SUBJECT: WASTEWATER PILOT PLANT RD&D PERMIT

The attached information addresses the questions and/or comments included in the telefax you sent to Mr. Cliff Clark, Department of Energy - Richland Field Office on February 19, 1993.

To: D. L. Flyckt
From: D. E. Scully
Subj: Responses to EPA's 2/19/93 FAX

Figure 4-1. Waste Water Pilot Plant Floor Plan.

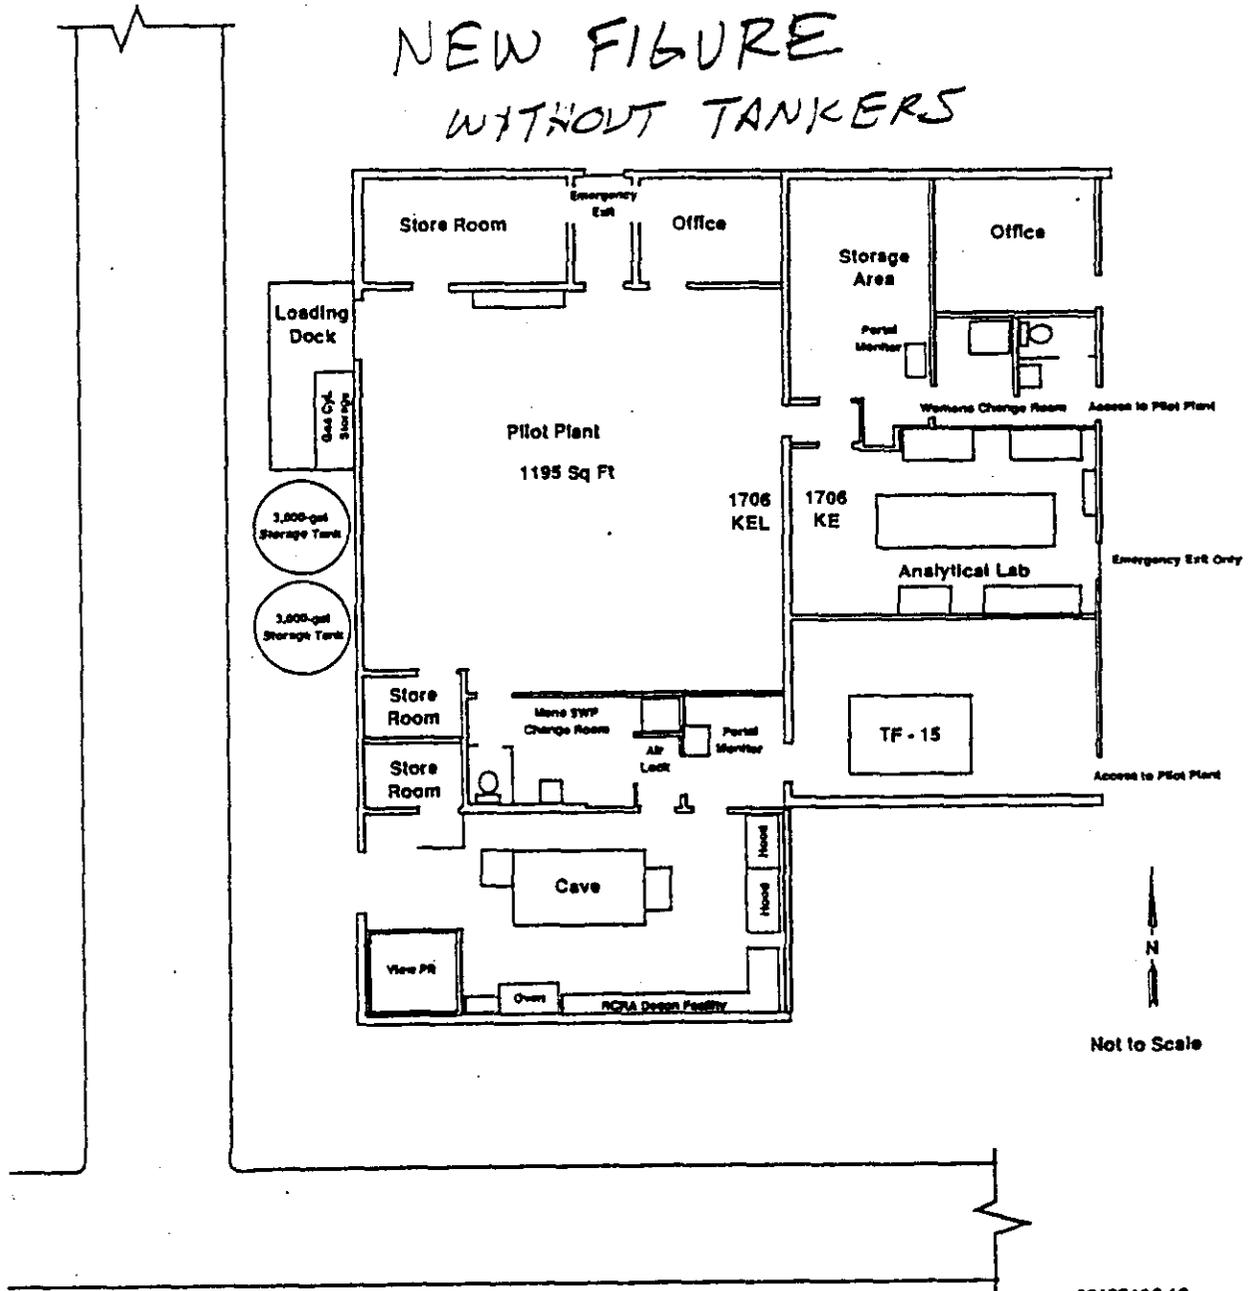
Attachment 2 addresses the fifth bullet, identified as *Figures 4-1 through 4-24 (Comments 36, 36)*. Included is the new Figure F4-1 showing the Waste Water Pilot Plant Floor Plan without tankers; the new Figure F4-23 showing the Waste Load/Unload Station at the 1706-KE Building; Figure F4-24 showing the Tank Trailer Configuration for Unloading at the 1706-KE Building (replaces Figure 4-23 in Rev. 1); Figure F4-25 showing the Tank Trailer Configuration for Loading at the 1706-KE Building (replaces Figure 4-24 in Rev. 1); and a new figure, F4-26, the Portable Berm Foundation Cross-Section.

NEW FIGURE WITHOUT TANKERS

Figure 4-23. Waste Load/Unload Station at the 1706-KE Building.

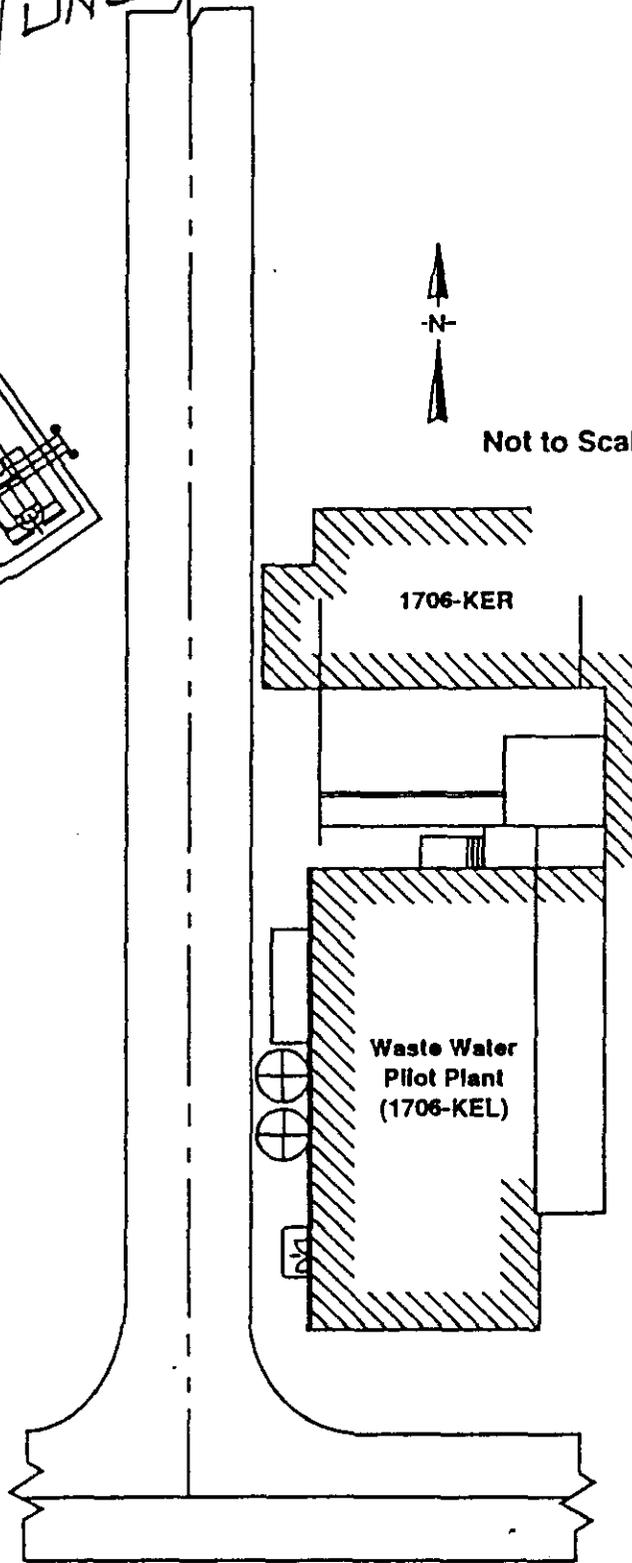
NEW FIGURE

SHOWS LOAD/UNLOAD AREA

Figure 4-24. Tank Trailer Configuration for Unloading at the 1706-KE Building.

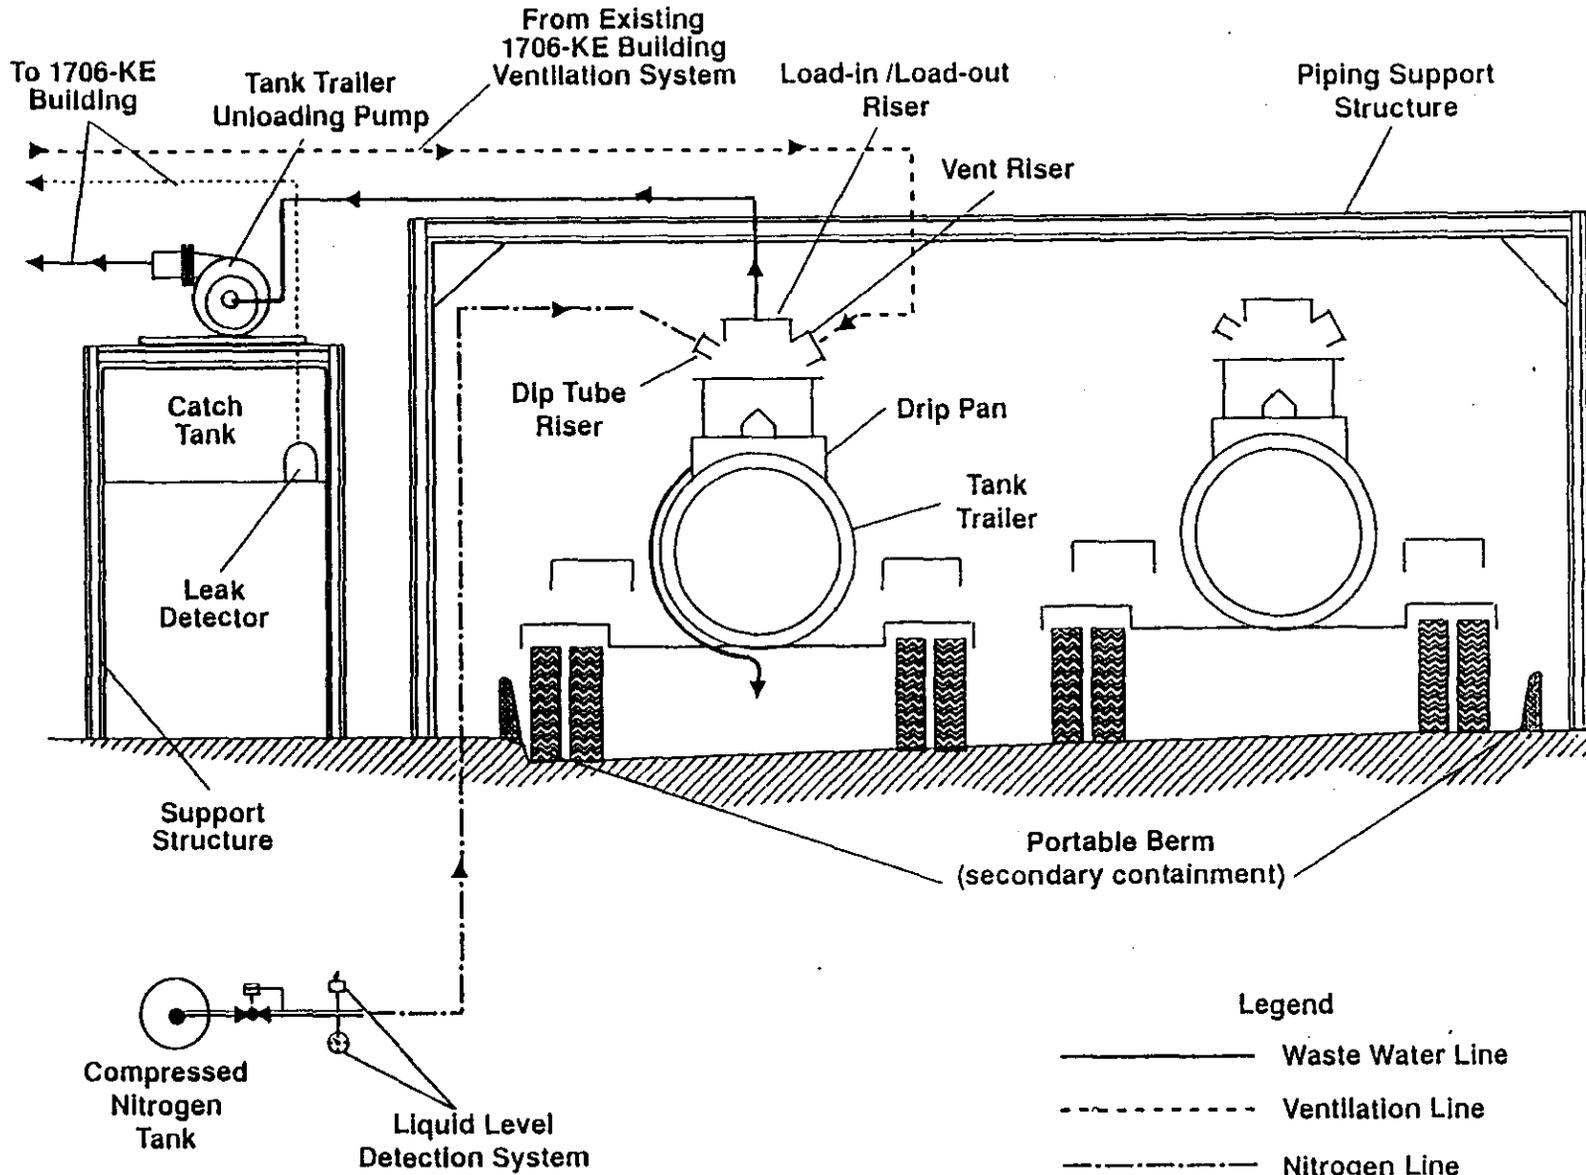
NEW FIGURE
REPLACES 4-23
IN REV 1

Figure 4-25. Tank Trailer Configuration for Loading at the 1706-KE Building.

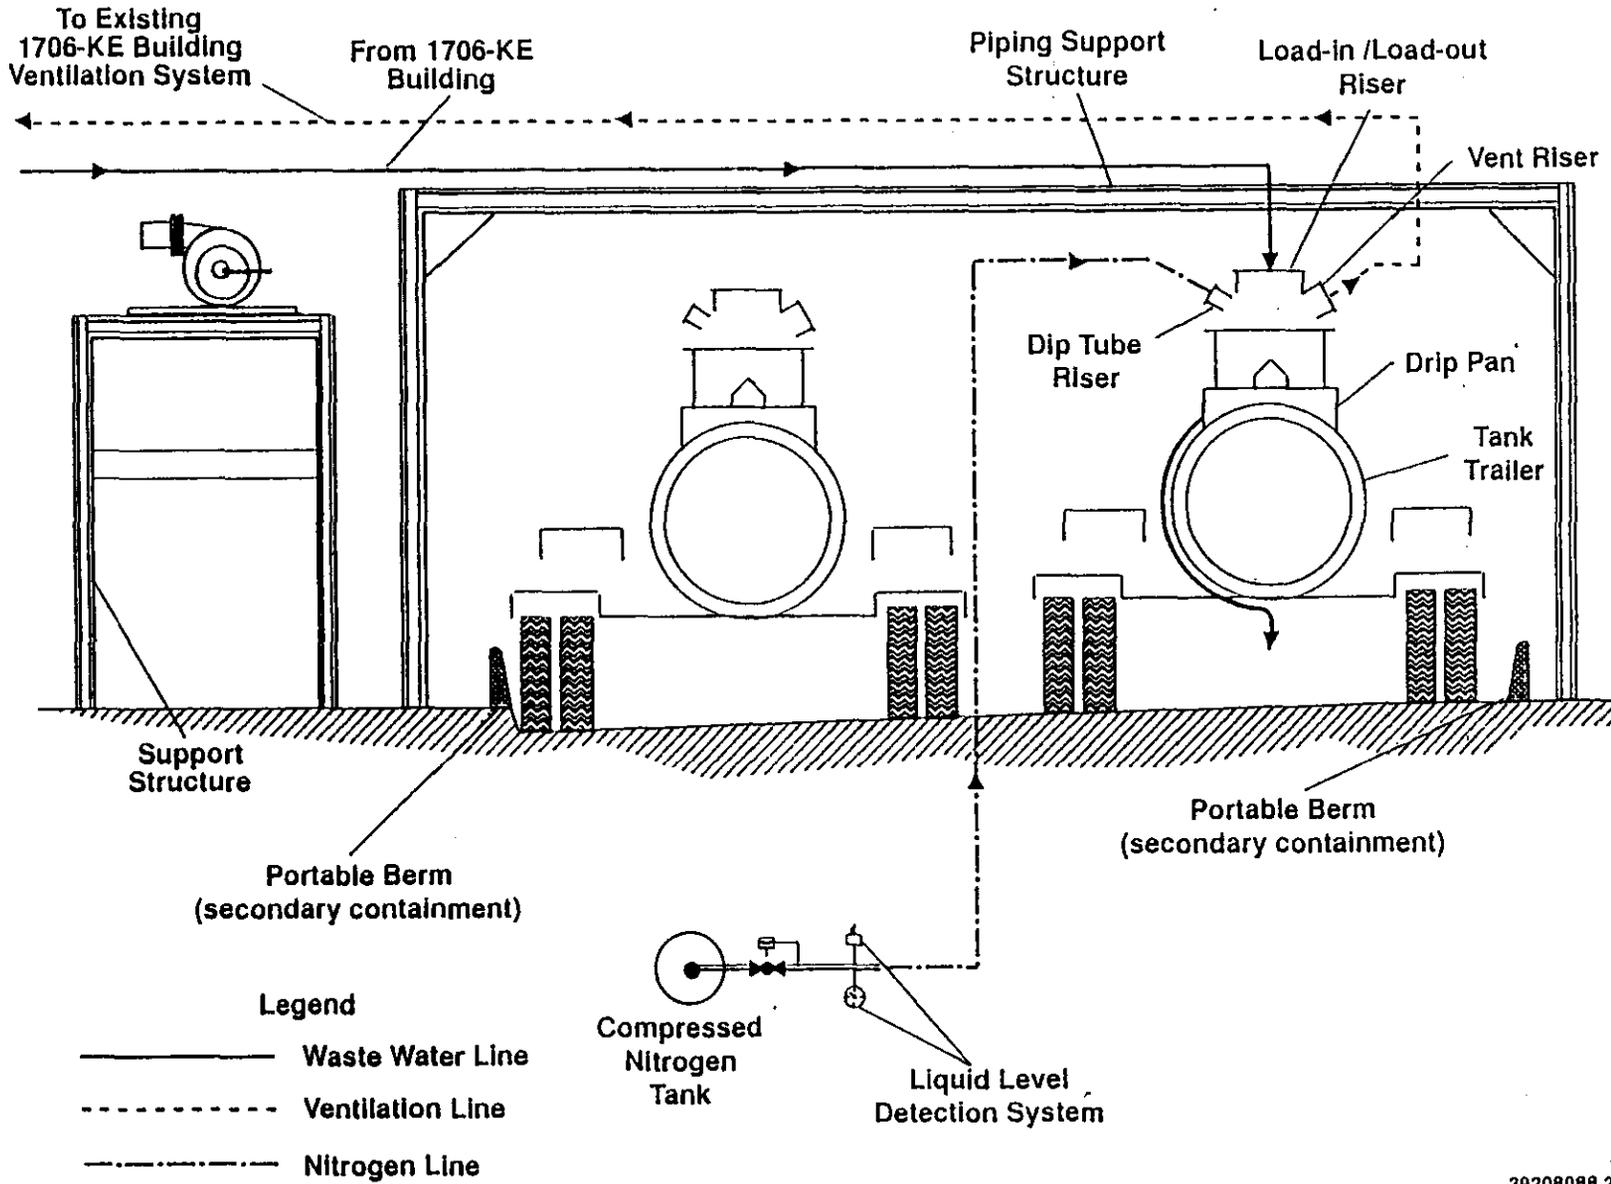
NEW FIGURE
REPLACES 4-24 IN REV 1

Figure 4-26. Portable Berm Foundation Cross-Section.

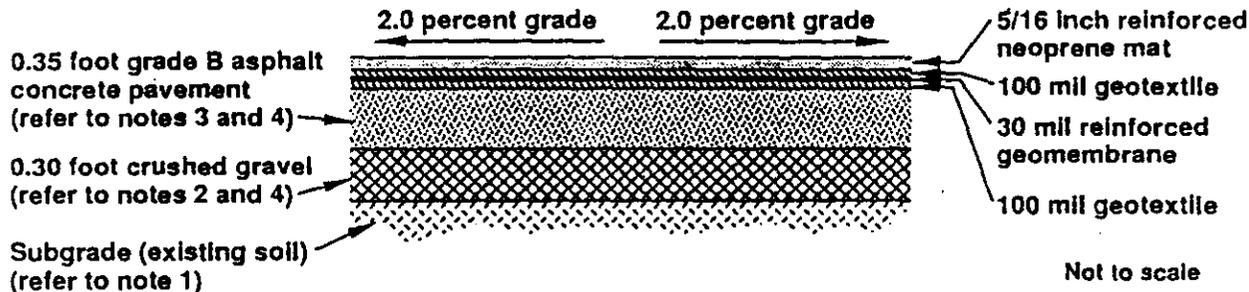
NEW FIGURE
